Charles W. Woodward High School, Final Forest Conservation Plan, MR2020022

7.<u>L</u>

Description

Figure 6: Plan Sheet L-1.4

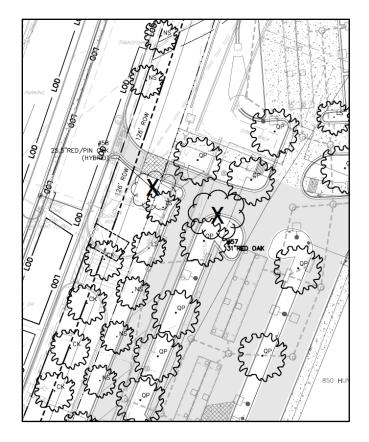
Staff continues to recommend the Planning Board grant variance approval for the removal of tree numbers 57, 59, 60, 61, and 62 (see Figures 6 & 7). No alternative design will avoid the removal of the trees within the center of the Property.

Figure 7: Plan Sheet L-1.1 part 1

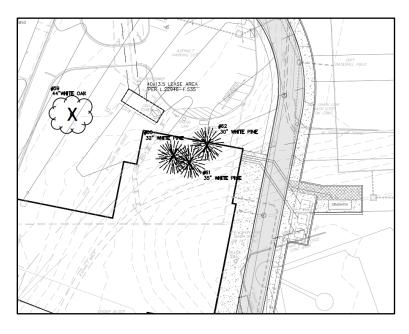
Variance tree numbers 37 and 38 are located on the eastern boundary adjacent to existing single-family homes (see Figure 8). The impact to these trees is due to significant grading associated with the site development. Staff supports this requested variance.

Figure 8: Plan Sheet L-1.1 part 2

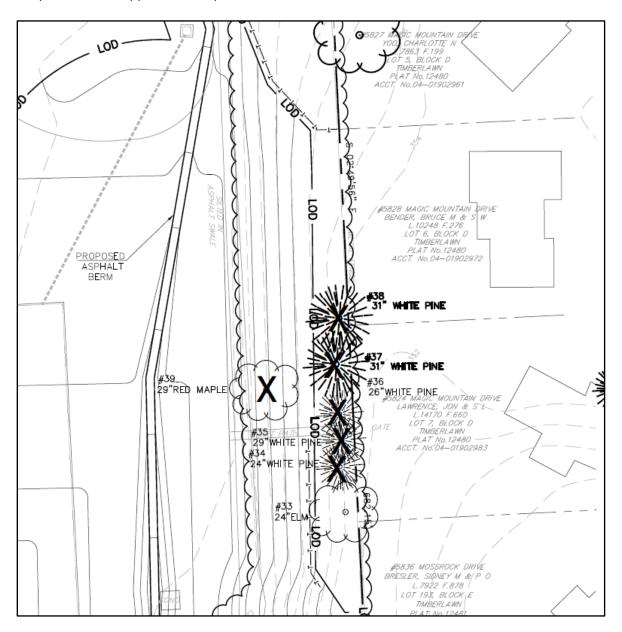
Variance trees numbers 50, 51, 52, 53, 54a, and 54b are located along the northern boundary and are proposed for removal to create the proposed parking lot (see Figure 10). The community raised concerns regarding tree removal along this portion of the site. Planning Staff supports this request due to the need for parking facilities associated with development of the school program. In addition, leaving these trees with a high level of impact to the critical root zone of each tree could result in an ensuing hazardous condition as some of the trees are highly susceptible to construction impacts.

Figure 11: Plan Sheet L-1.2 part 1

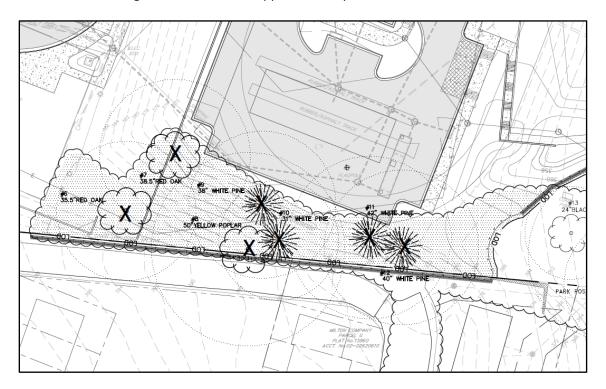
Variance trees number 6, 7, 8, 9, 10, 11, and 12 are located on the southern boundary (see Figure 11). Planning staff understands these trees will impacted due to proposed retaining walls, grading and electric utilities. Planning Staff recommends approval to impacts to these trees.

Variance tree number 17 is located on the southern boundary of the Property, in a location proposed for a sewer connection and pedestrian path to connect to Timberlawn Local Park (see Figure 12) as a part of a Park Permit process. Planning staff supports the sewer connection and path to impact Variance tree number 17.

Figure 12: 4Plan Sheet L-1.2 part 2

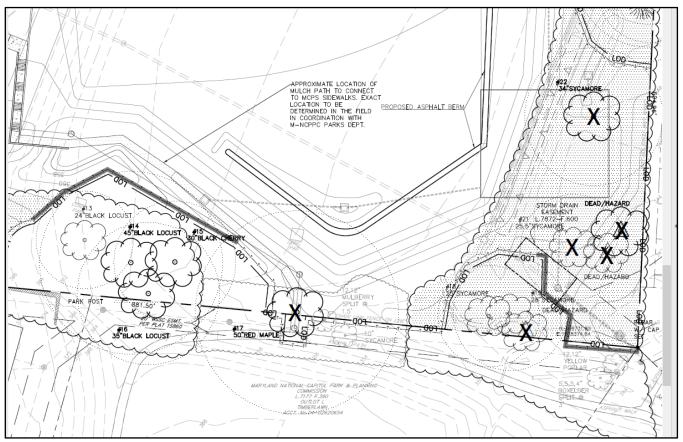
Variance tree number 22 (see Figure 12) is being removed due a proposed storm drain structure and grading constraint. Planning staff support this request.

Figure 13: 5Plan Sheet L-1.3

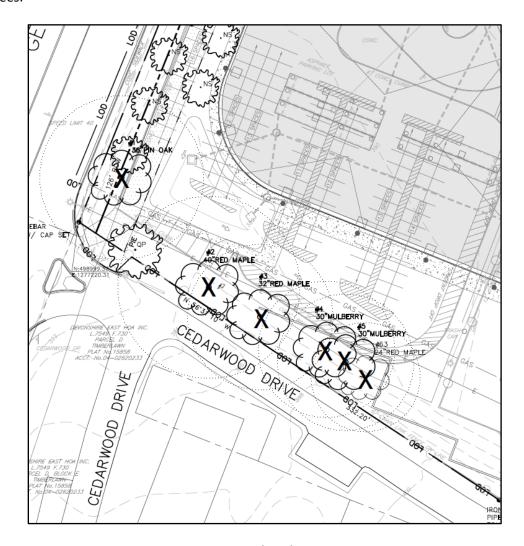
Variance trees number 1, 2, 3, 4 and 5 are located on the southeastern boundary corner (see Figure 13). These trees are located in an area with grade constraints and the Applicant proposes to provide retaining walls and a sidewalk connection into the site. Planning staff support this request to remove these trees.
